## Technical Review Board

**Subject: Maryvale Work Plan Variation**

This letter is presented in response to a request from the Department to advise the Minister on the Maryvale Work Plan Variation (WPV) for Yallourn Mine.

**Figure 1: Summary of Direct Shear Test Results – Peak and Residual Strengths (after Reference 7)**

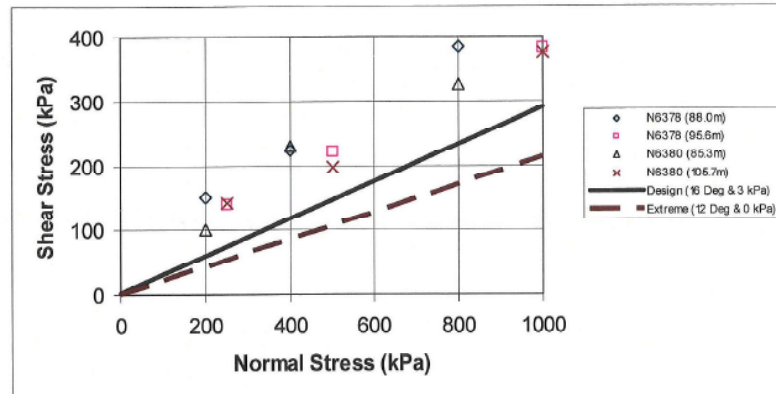
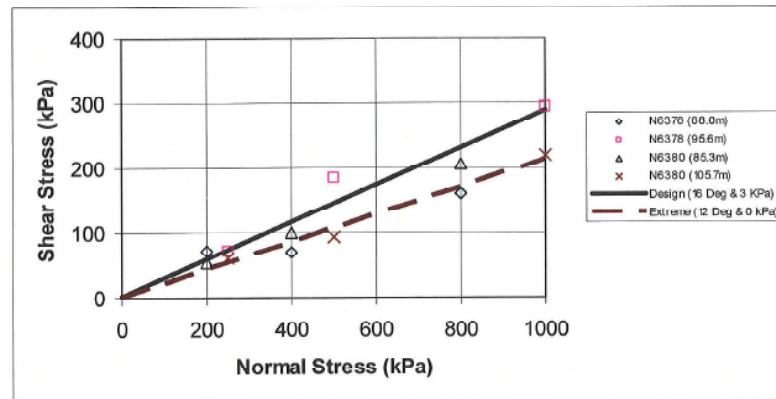
These new laboratory test results for the N63 series boreholes are also included in Table 1 and give residual angles of friction of 10° to 16°. Figure 1 presents this recent test data.

The 12° angle of friction is based on actual testing of a known weak layer, along which the large scale block movement had occurred. This layer also appeared to be a pre-existing geological structure. Recent testing of samples of similar low strength layers from clay seams beneath the MRD gave lower residual angles of friction, 10° and 11°.

In this context, it is difficult to see how an angle of friction of 12° could be called “extreme”. Rather this appears to be a strength towards the lower bound of the envelope of strengths obtained by testing of clay layers. However if the population selected for testing and design is only “weak clay layers” then this would not be either the lower bound or the extreme value, but the design value for weak clay layers. In a layered horizontally bedded sedimentary sequence experience dictates that if weak clay layers are present, then this is the design case strength.

In this case, the design FOS generated for the MRD, may actually be too high and the “design” FOS for the slope should be based on 12°. Thus, it would be closer to 1.0 or 1.1 rather than 1.5.
